PLANNING COMMISSION AGENDA REPORT

MEETING DATE: MAY 13, 2013

SUBJECT: PLANNING APPLICATION PA-12-20 / TENTATIVE TRACT MAP TT-17551 FOR A DESIGN REVIEW AND SUBDIVISION MAP FOR A 5-UNIT COMMON INTEREST DEVELOPMENT WITH SPECIFIED VARIANCES AND DEVIATIONS
2573 ELDEN AVENUE

SITE PLAN
SCALE: 1" = 40'-0"

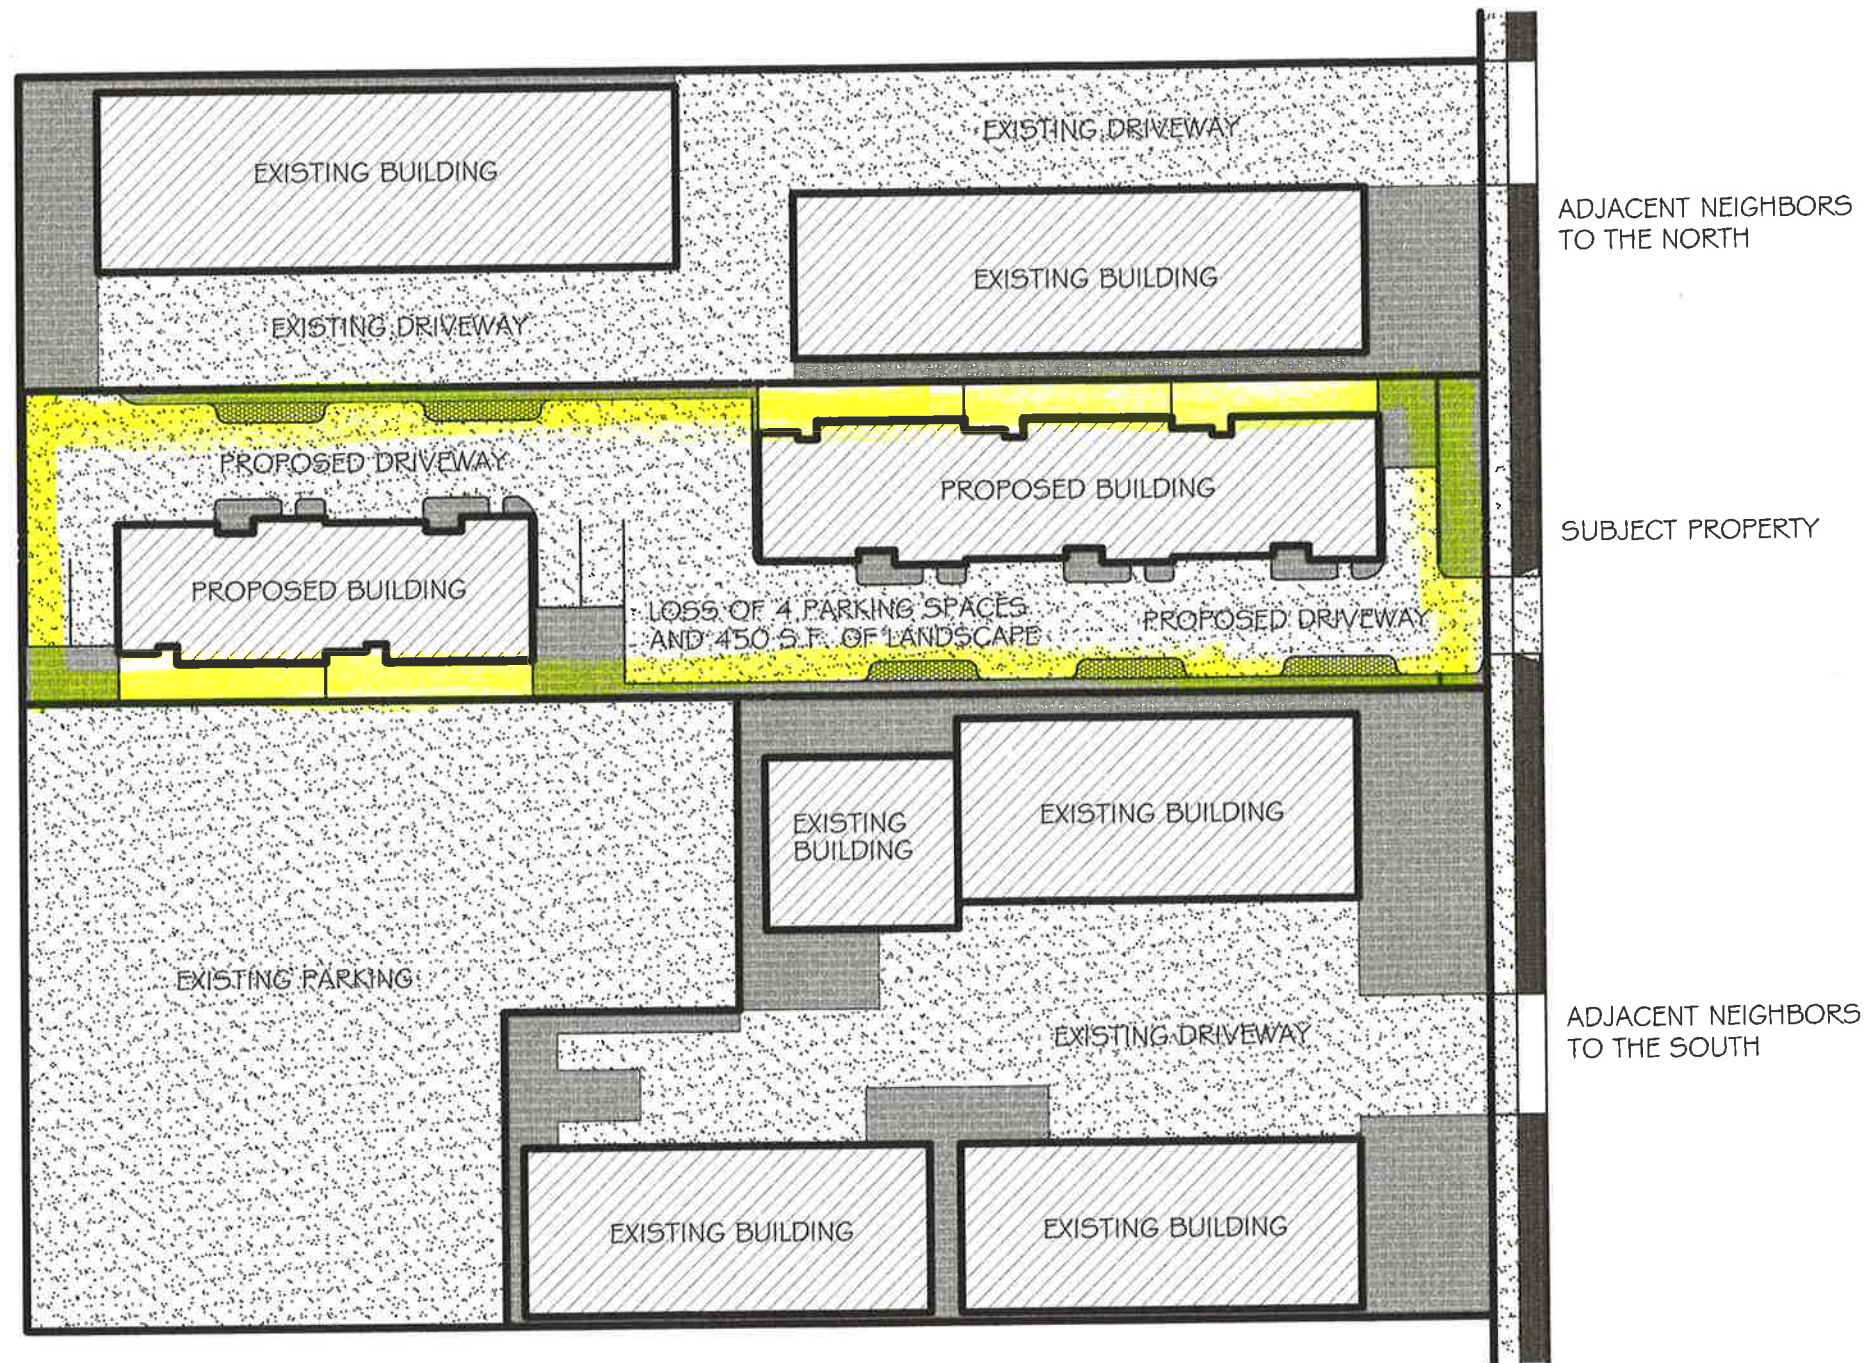
Description: This alternative shifts Building 2 (the rear building) from the northerly side of the property to the southerly side of the property, resulting in a jogged central driveway through the project.

OPTION 1

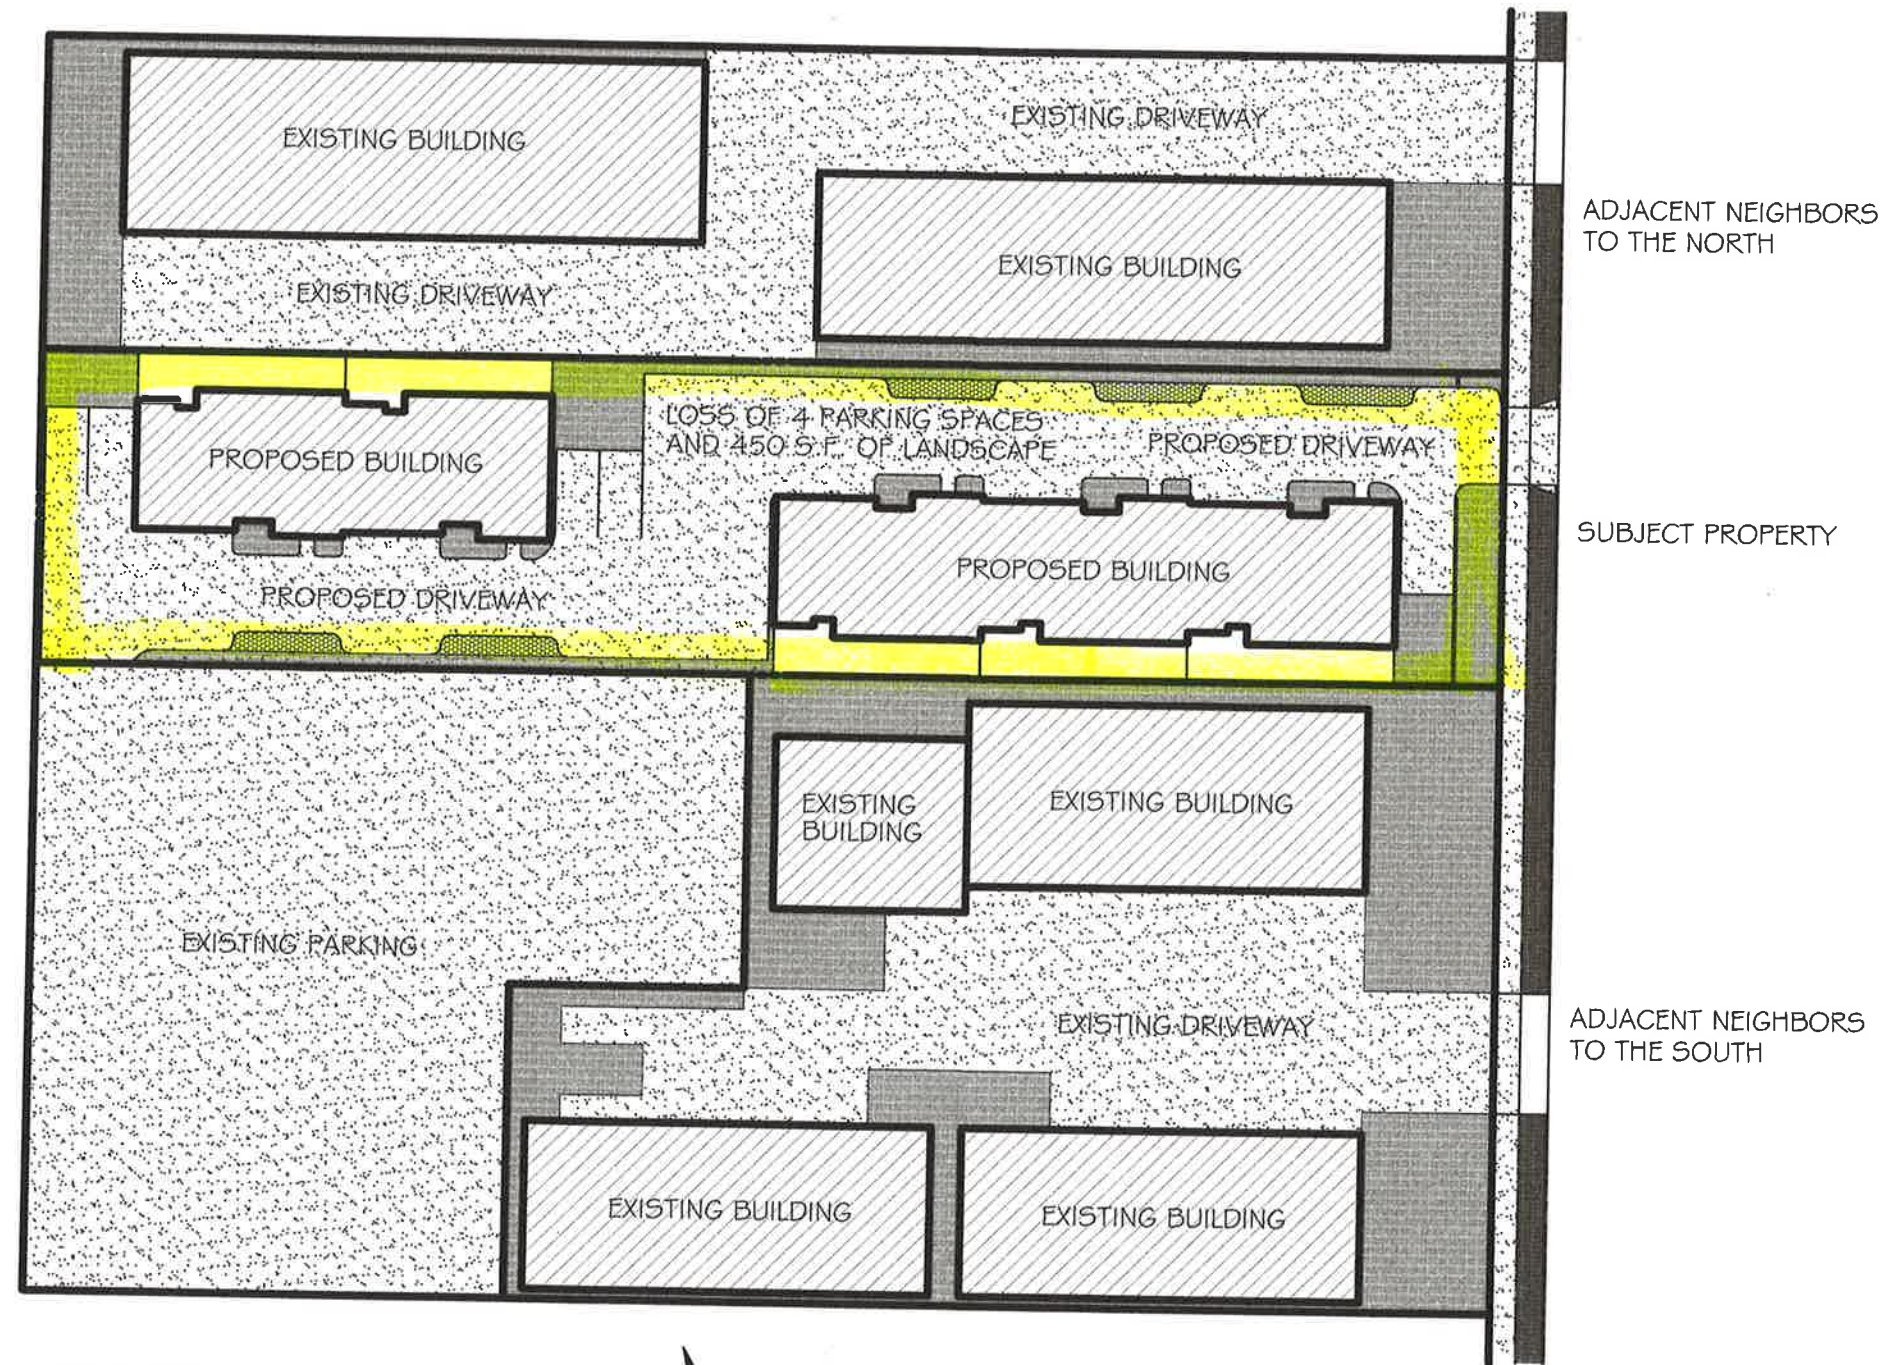
Description: This alternative shifts Building 1 (the front building) from the northerly side of the property to the southerly side of the property, resulting in a jogged central driveway through the project.

OPTION 2

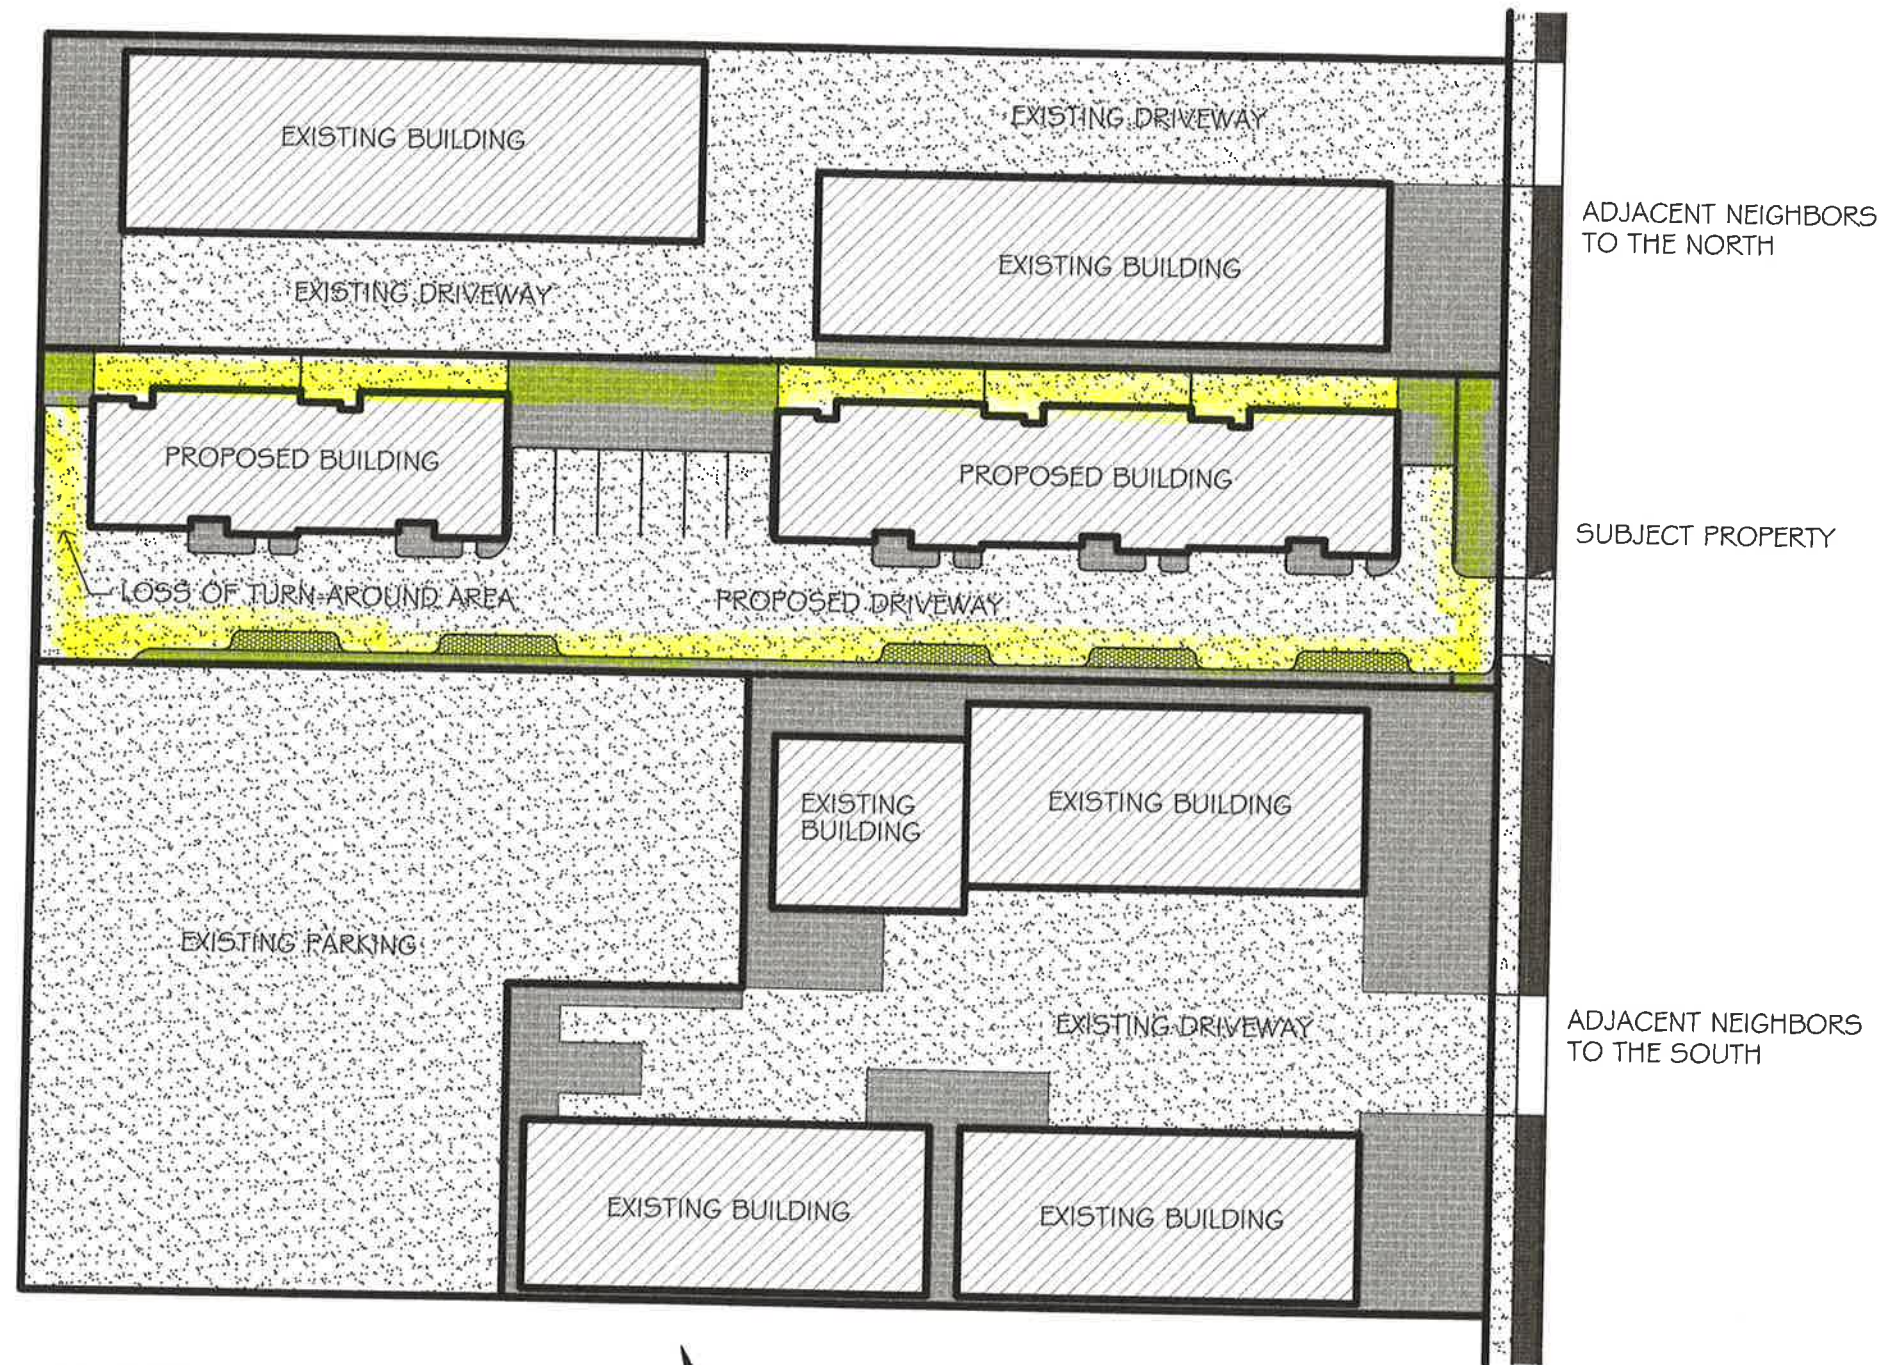
Description: This alternative shifts Building 2 (the rear building) further to the rear of the property (abutting commercially-zoned property) by relocating one of the two open parking spaces to the area between the two buildings.
